Access Compliance Report

Public Rights-of-Way

Intersection ID: 48000	Main Street: LANZERAC MANOR DR	Cross Street: CLYMER CT	Location: SW
ADA ID: E04CA9A98EF7	Ramp Type: PerpDiag	Initial Pass/Fail: Fail	Overall Compliance: No
		Severity Score: 10

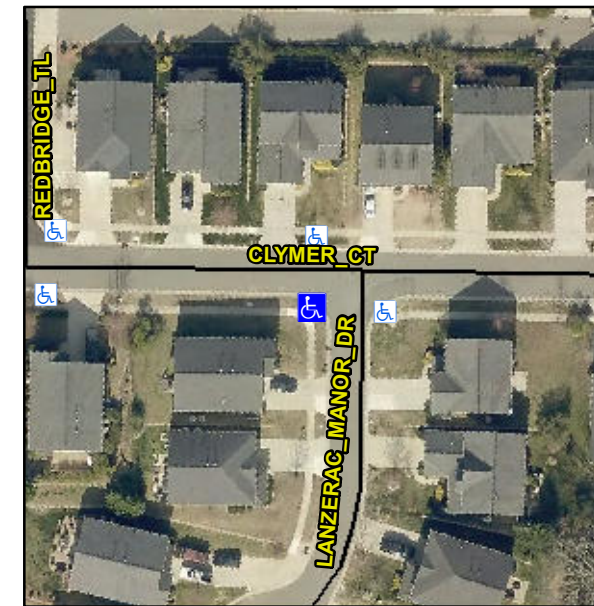
Not Found, R304.5.1, R304.5.3

Compliance	Description	Data	Compliance	Description	Data
N/A	Ramp Length (in)	72.0	Yes	Ramp Slope (%)	7.1
No	Ramp Width (in)	46.0	No	Ramp XSlope (%)	4.9
N/A	Flare Type LT	N/A	N/A	Flare Type RT	N/A
N/A	Flare Slope LT (%)	N/A	N/A	Flare Slope RT (%)	N/A
N/A	Flare Traversable LT?	N/A	N/A	Flare Traversable RT?	N/A
N/A	Landing Length (in)	N/A	N/A	DWS Provided?	N/A
N/A	Landing Width (in)	N/A	N/A	DWS Contrast?	N/A
N/A	Landing Slope (%)	N/A	N/A	DWS Length (in)	N/A
N/A	Landing X Slope (%)	N/A	N/A	DWS Full Width?	N/A
N/A	Landing Curb? (Y/N)	N/A	N/A	DWS Offset (in)	N/A
N/A	Shared Landing?	N/A			
N/A	Gutter Ponding?	N/A	N/A	Gutter Slope (%)	N/A
N/A	Gutter Lip Ht (in)	N/A	N/A	Gutter X Slope (%)	N/A
N/A	Painted X Walk1?	No	N/A	Painted X Walk2?	No
	X Walk 1 Direction	To E		X Walk 2 Direction	To N
N/A	X Walk 1 Width (in)	N/A	N/A	X Walk 2 Width (in)	N/A
	X Walk 1 Slope (%)	5.2		X Walk 2 Slope (%)	3.7
	X Walk 1 X Slope (%)	5.8		X Walk 2 X Slope (%)	5.5

Remove & Replace Curb Ramp With Two New Directional Ramps or Equivalent.
